January 2019

Subject: Software updates for Cardiac Resynchronization Therapy Defibrillators (CRT-Ds) and Pacemakers (CRT-Ps) address the November 2018 Positive Left Ventricular (LV) Offset Interaction (see previous communications issued in December 2017 and more recently November 2018 with reference 92179817-FA).

Boston Scientific Software Update Addresses Positive LV Offset Interaction

Appendix A – Identification of Programmer Software

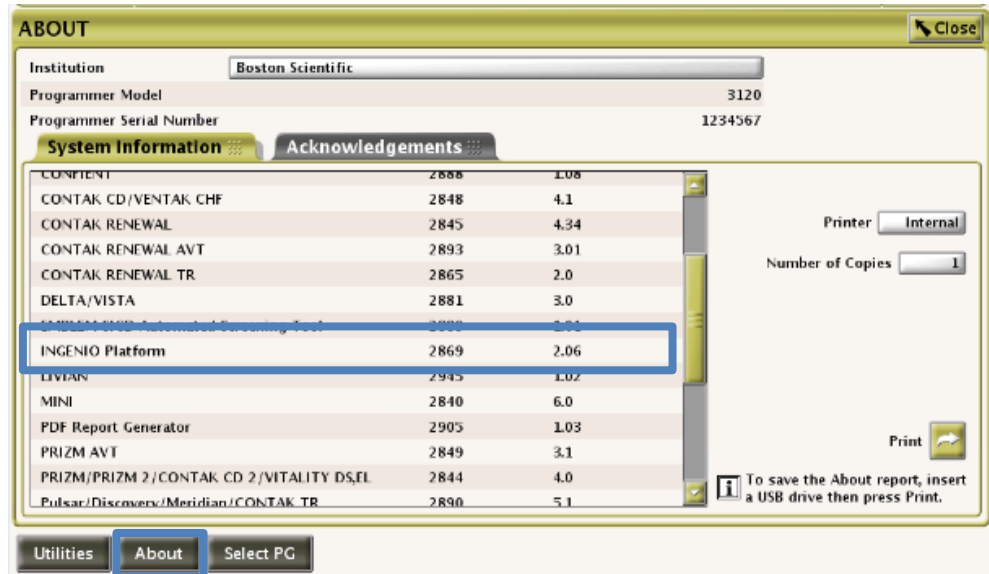
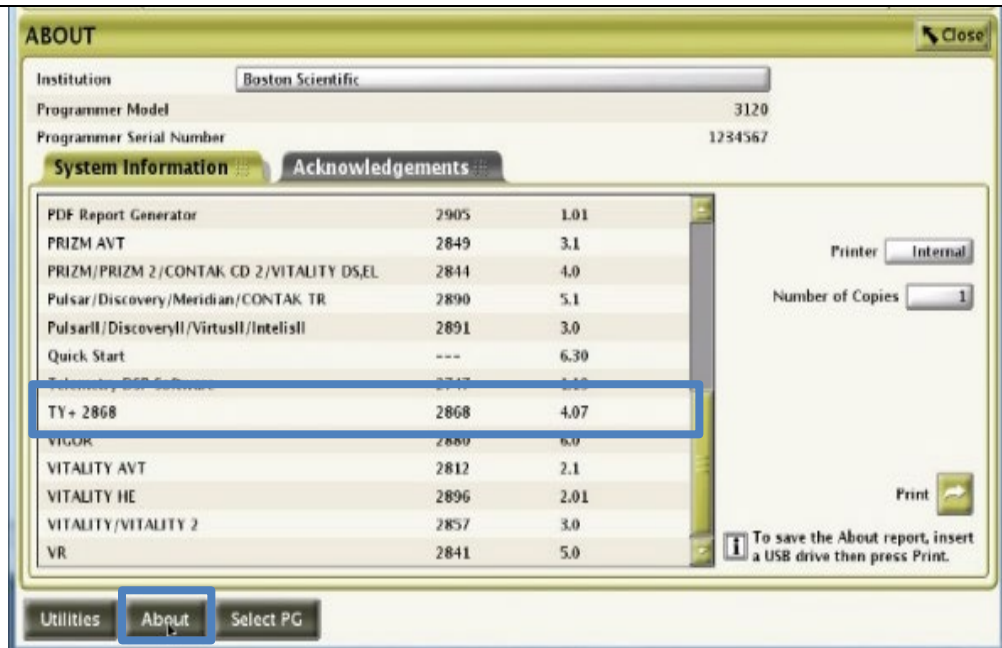
Select About button and Confirm Software Model and Version

Model 2869 v2.06 supports CRT-Ps in Table 1

Previously released model 2868 v4.07 supports CRT-Ds in Table 2
